WILSON RESIDENCE
612 JUAN ANASCO DR
LONGBOAT KEY
RESIDENTIAL POOL
POOL PLAN
EASON BUILDERS GROUP

PERMIT NUMBER: PSPS22-0076

RE: 612 Juan Anasco Drive, Longboat Key 34228
Pool Permit # PSPS22-0076

Per owner and designer request, the pool shape has been reduced to allow space for pickleball court in the rear. Changes from previous plan include the following:

1 SITE POOL PLAN
SCALE: 1" = 20'-0"

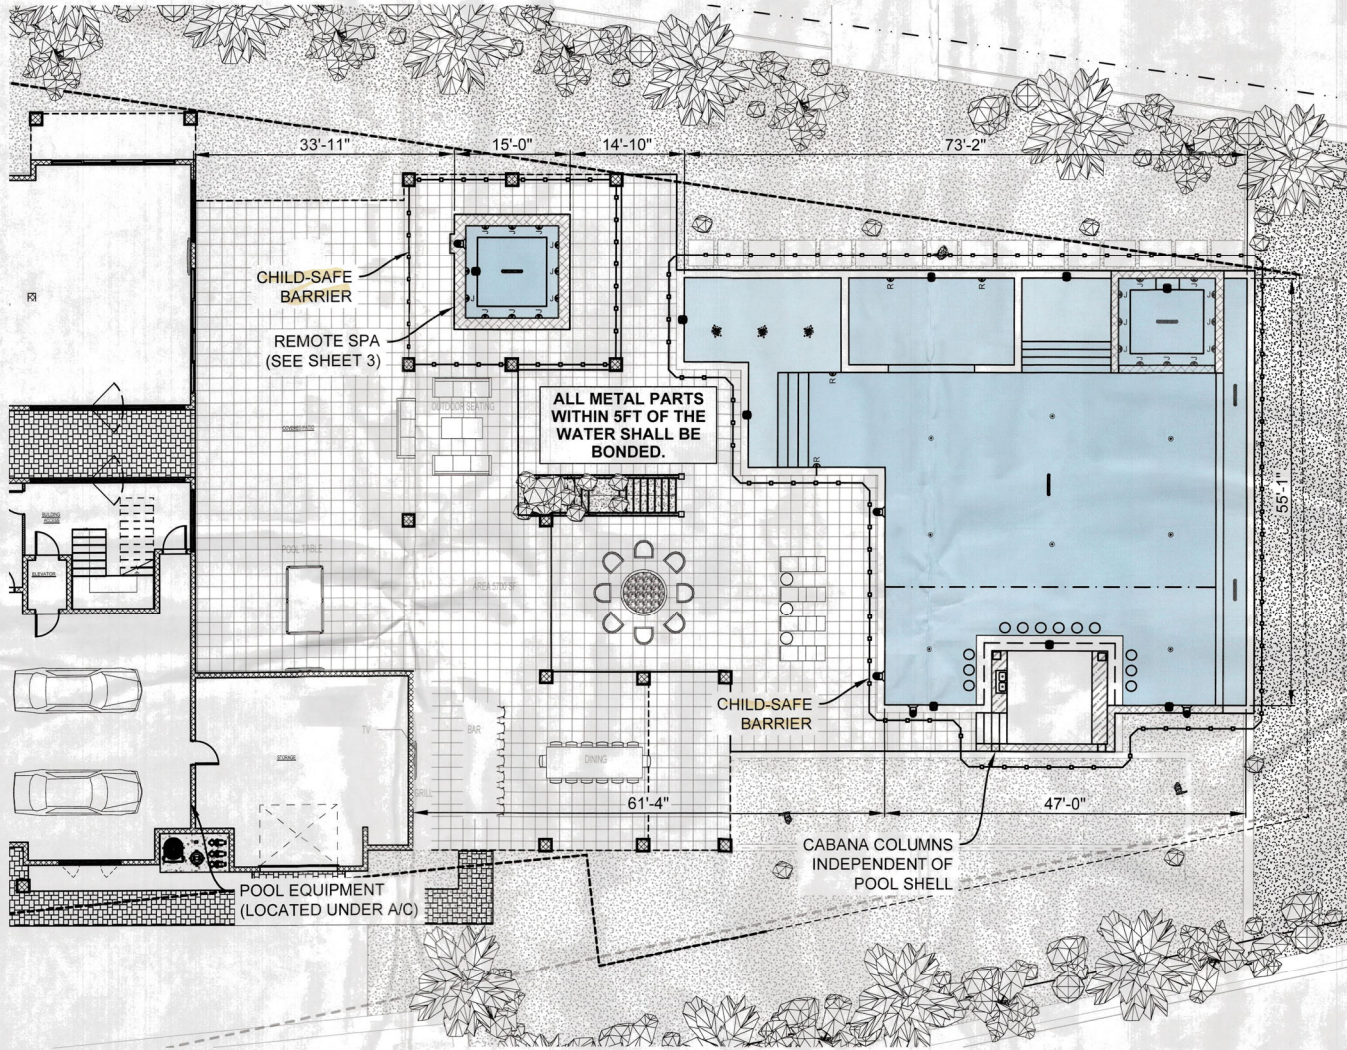
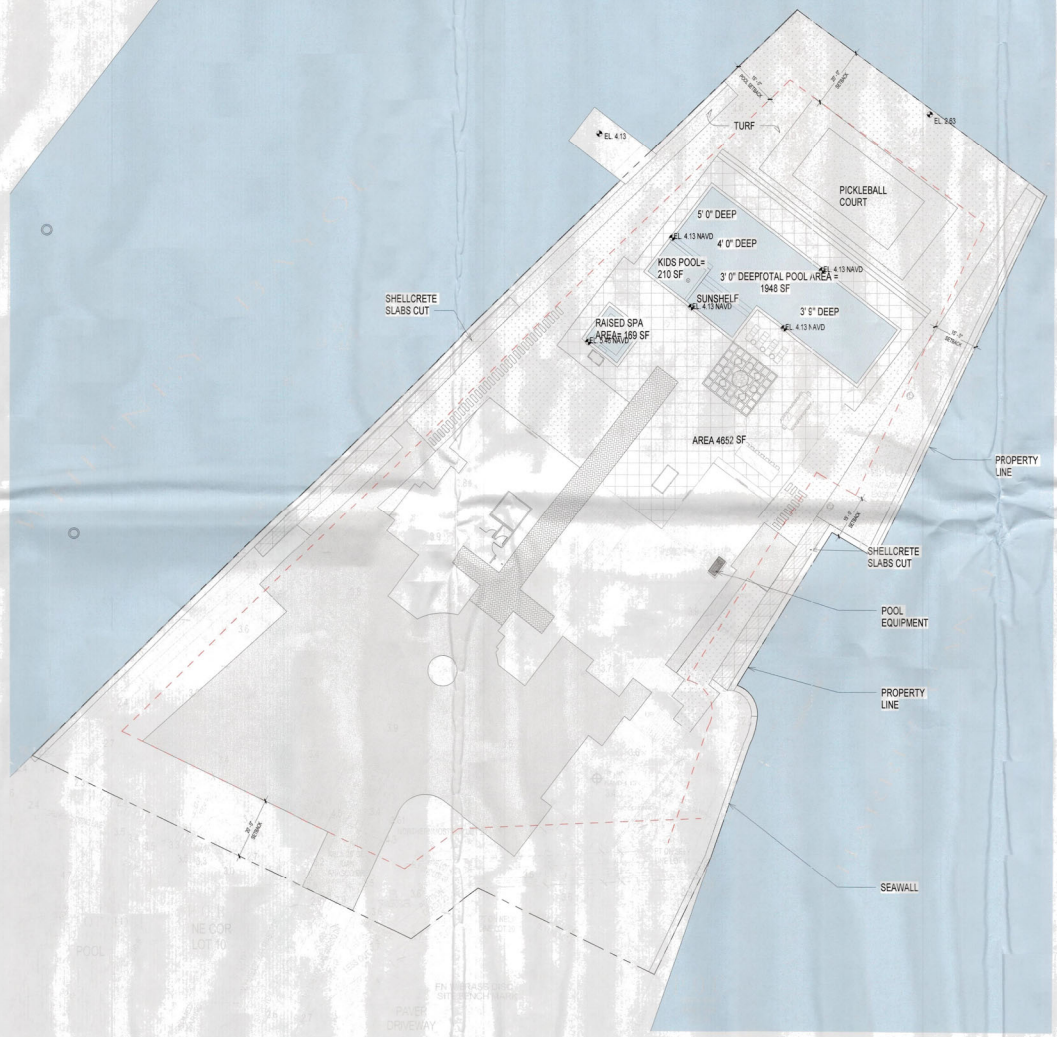
- Delete Sunken Bar
- Delete Tanning Ledge
- Delete second hot tub
- Move Baby Pool
- Change depth of baby pool to 12"
- Change Deep area to 4'
- Add Bench on Each End
- Width of main pool is 24'
- Length of main pool is 56'
- Pickleball ball court is 30' wide by 60' long (includes 10' padding on both ends and 5' padding on both sides).
